**KU-RING-GAI PLANNING PANEL
TO BE HELD ON WEDNESDAY, 23 MARCH 2011 AT 5.00PM
LEVEL 3 COUNCIL CHAMBERS
818 Pacific Highway, Gordon**

- GB.1 **29 Church Street, Pymble - Alterations and Additions to a Heritage Item** **6**

- GB.2 **6, 6A, 8, 10 & 10A Beaconsfield Parade, Lindfield** **70**

APPLICATION NO:	DA0849/10
PROPERTY DETAILS:	29 Church Street, Pymble Lot & DP No: C 342616 Site area: 4,260m ² Zoning: Residential 2(c) Ward: St Ives
PROPOSAL:	To determine Development Application 0849/10, which proposes alterations and additions to a dwelling house that is listed as a heritage item on schedule 7 of the Ku-ring-gai Planning Scheme Ordinance (KPSO).
TYPE OF CONSENT:	Local
APPLICANT:	G & M Khannah
OWNER:	G & M Khannah
DATE LODGED:	16 November 2010
RECOMMENDATION:	Refusal

WORKING DRAWING - BASEMENT & ATTIC PLANS
DATE - OCTOBER 2010
SCALE - 1:50
PROJECT NO. 1010 - MIDLAND
ARCHITECTS
P.O. BOX 664 WARRONGHEE, 2070
(02) 9489 1016

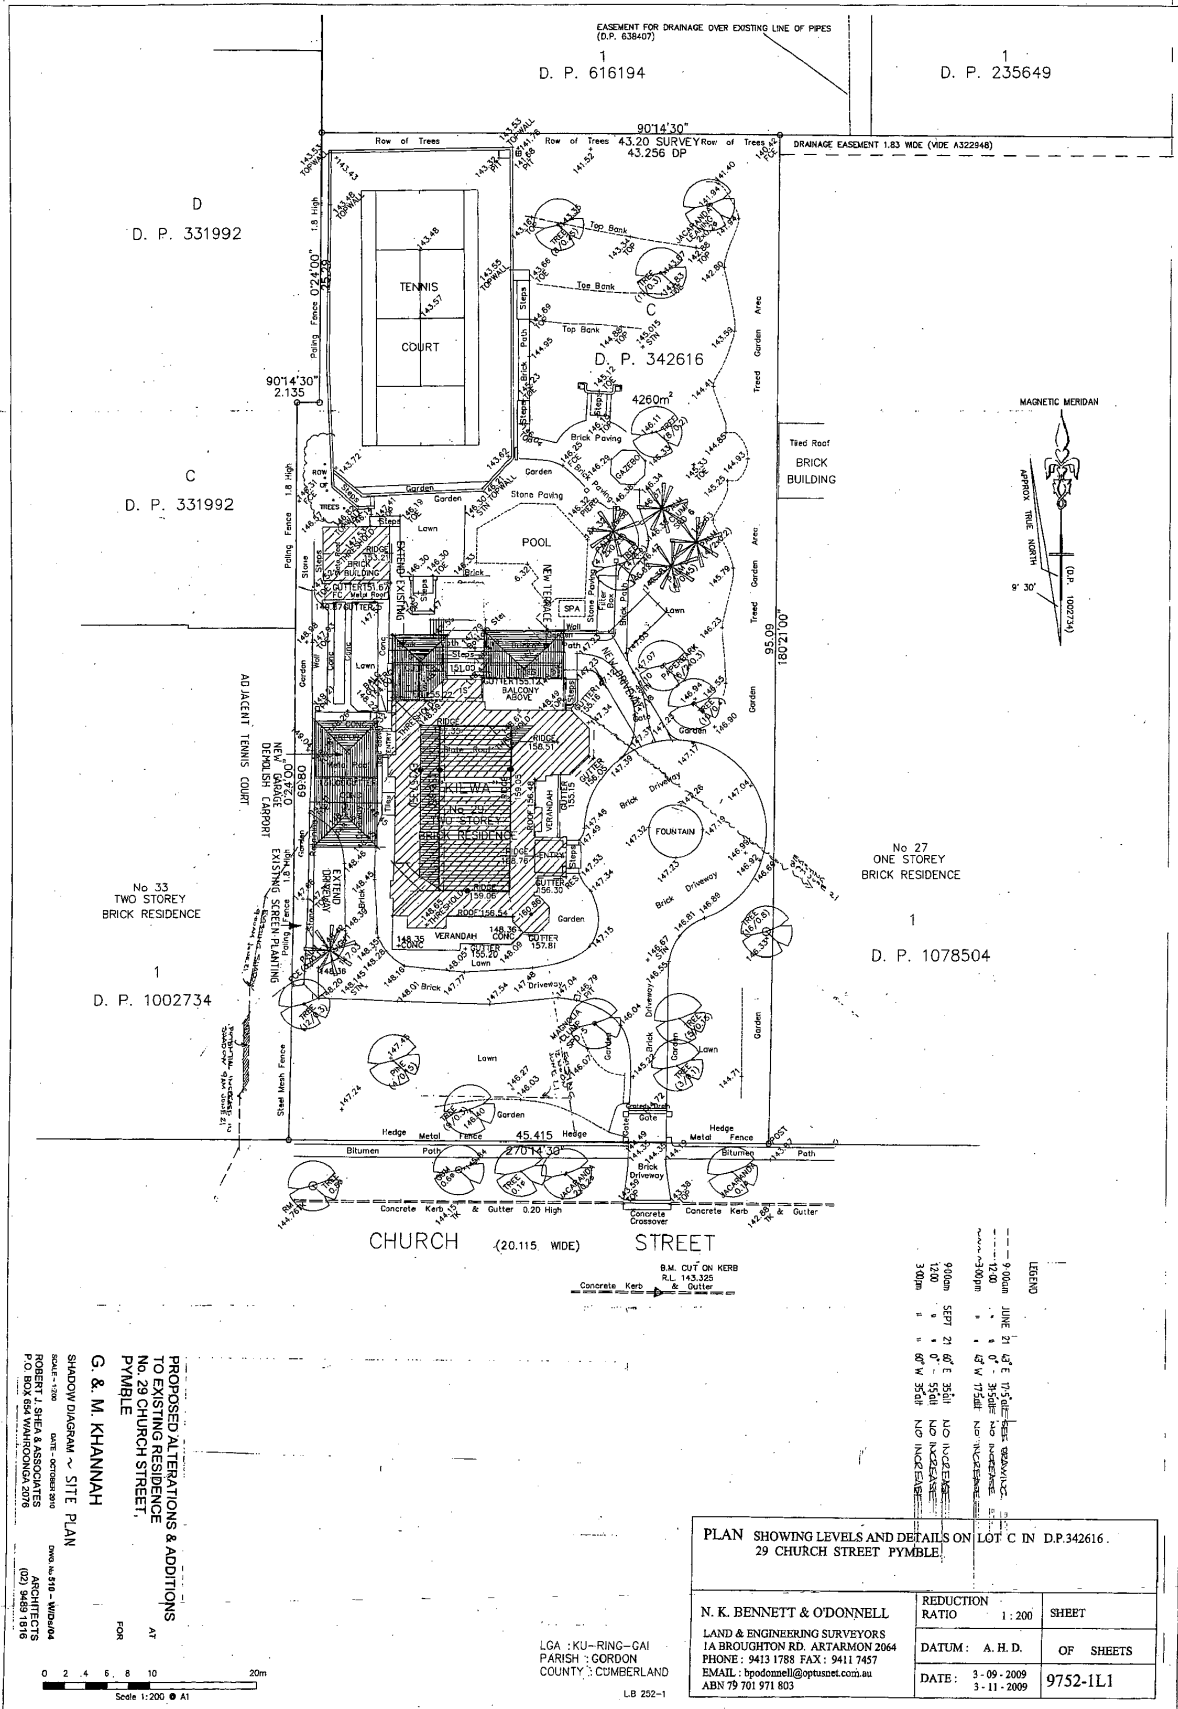
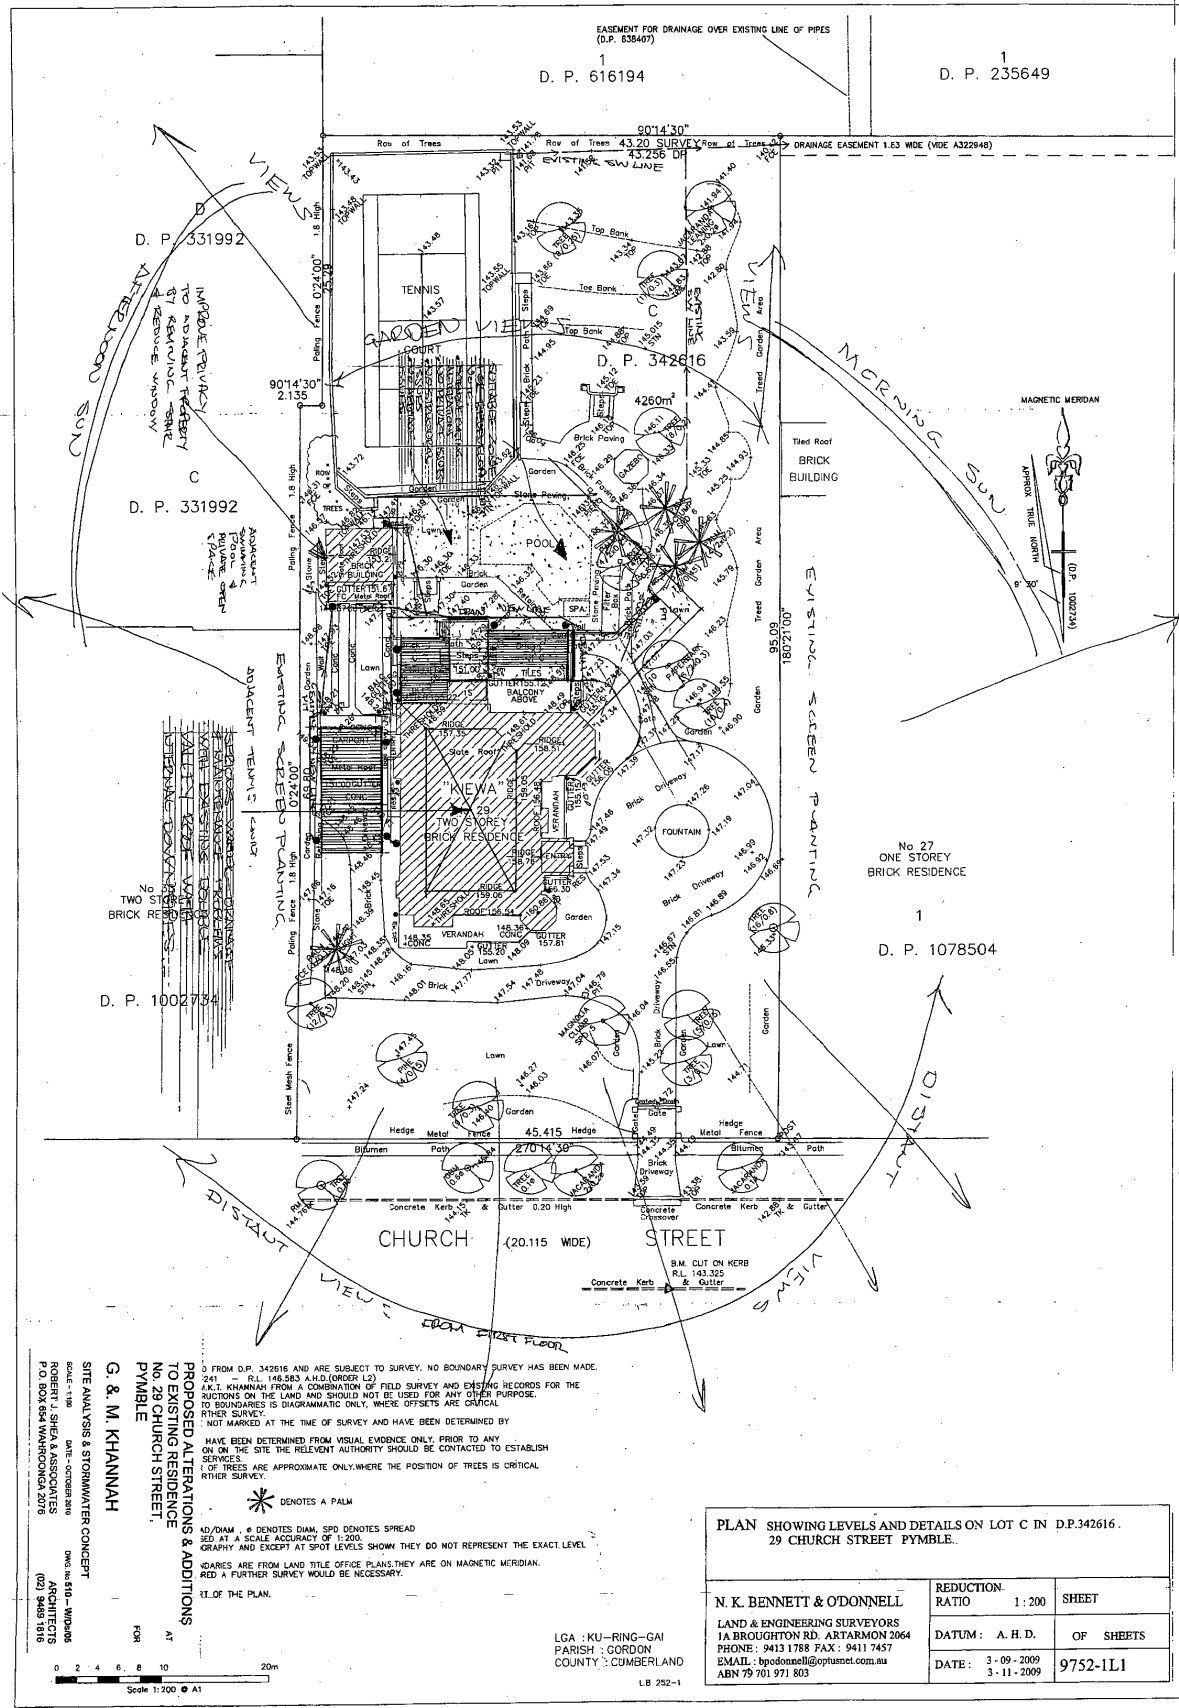
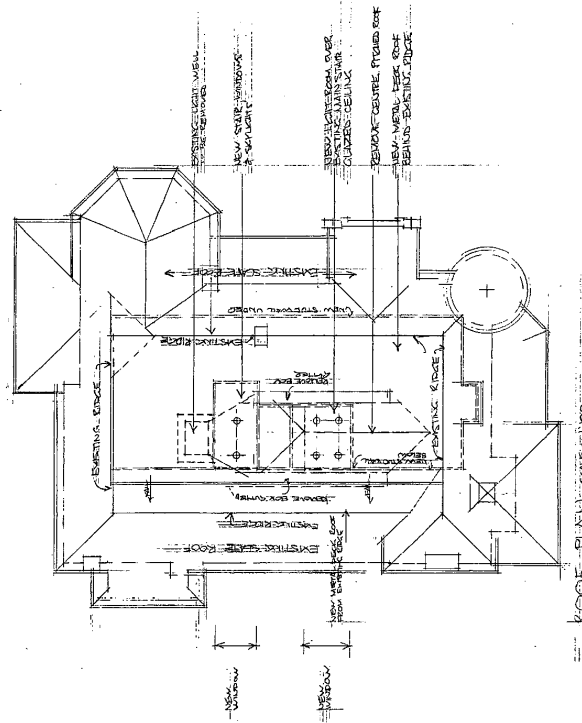
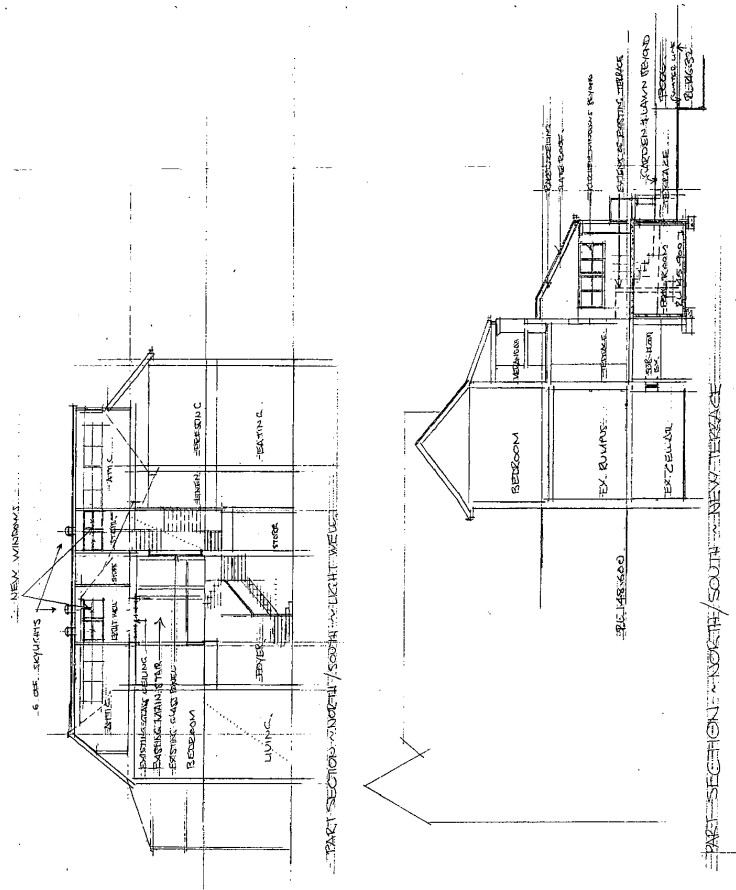
The revised application has removed the spiral stair and proposes a new stair from the corner of the rumpus room to the cellar. This is an improvement on the previous location. However, it is not an ideal location for a stair. It is considered that a more appropriate solution would be a new stair from the eating area to the cellar and new pool room without making any change to the rumpus room which is one of the highly significant rooms in the item.

The roof plan shows additional skylights above the new stair to the attic level room. The applicant has demonstrated that additional daylight will be available to backlight the existing stained glass and leadlight window to the north of the main stair. This is now considered to have minimal heritage impacts and is satisfactory.

The proposed attic has a building height of 10m, breaching the prescribed development standard set out under clause 46(2) of the KPSO by two metres. A SEPP 1 has been submitted that has been considered earlier in this report. Council officers are unable to support the SEPP 1 objection because it was not set out in accordance with the five part test in *Winten Property v North Sydney (2001)* and failed to address the correct planning instrument.

Figure 2: Proposed building footprints on Lot A (DA0987/08) & Lot B (DA0988/08).

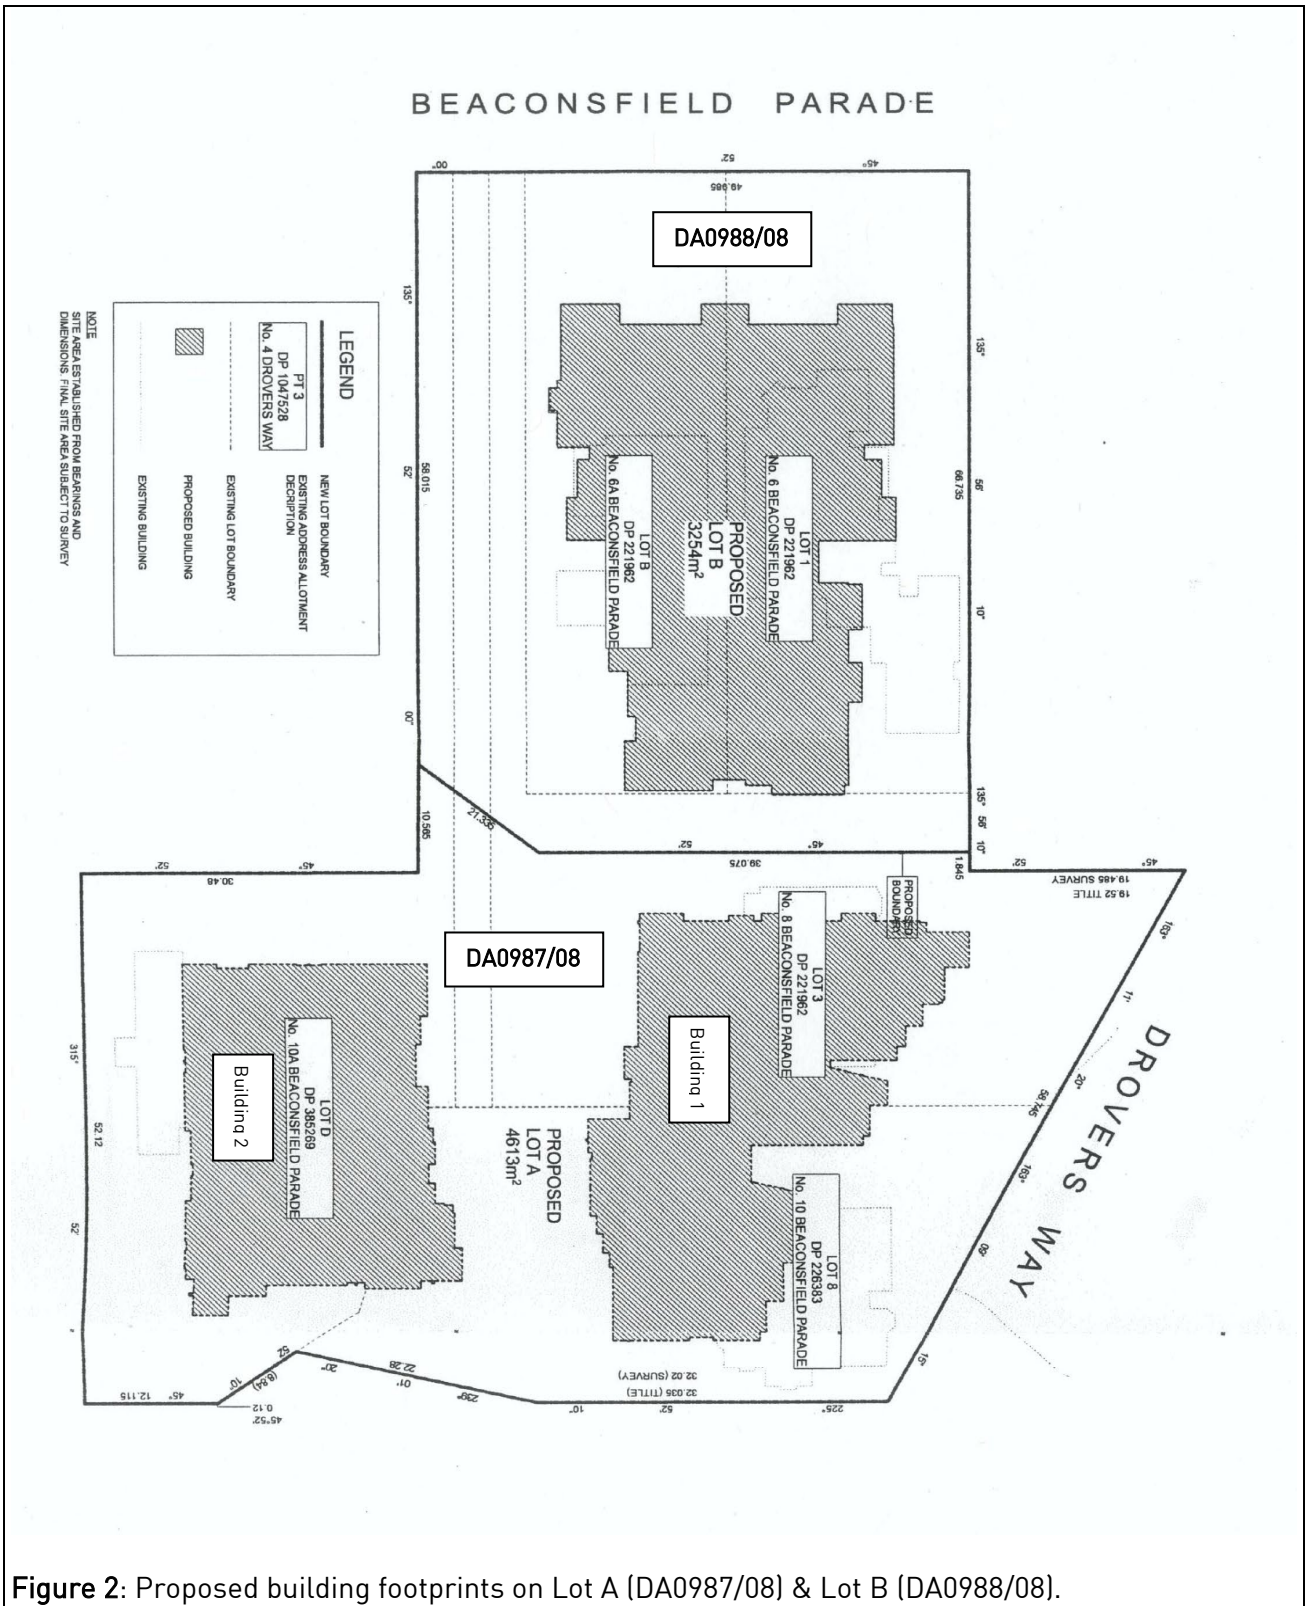
- DA0987/08 involves redevelopment of proposed Lot A under DA0986/08. The proposed works include demolition of existing dwellings and erection of 2 x 5 part 6 storey residential flat buildings (identified as Building 1 and Building 2 on Figure 2) containing 68 units, basement carparking and associated landscape works. Vehicular access to the development is from Drovers Way.

- DA0988/08 involves redevelopment of proposed Lot B under DA0986/08. The proposed works include demolition of existing dwellings and erection of 1 x 5 part 6 storey residential flat building containing 40 units, basement carparking and associated landscape works (Figure 2). Vehicular access to the development is from Beaconsfield Parade.
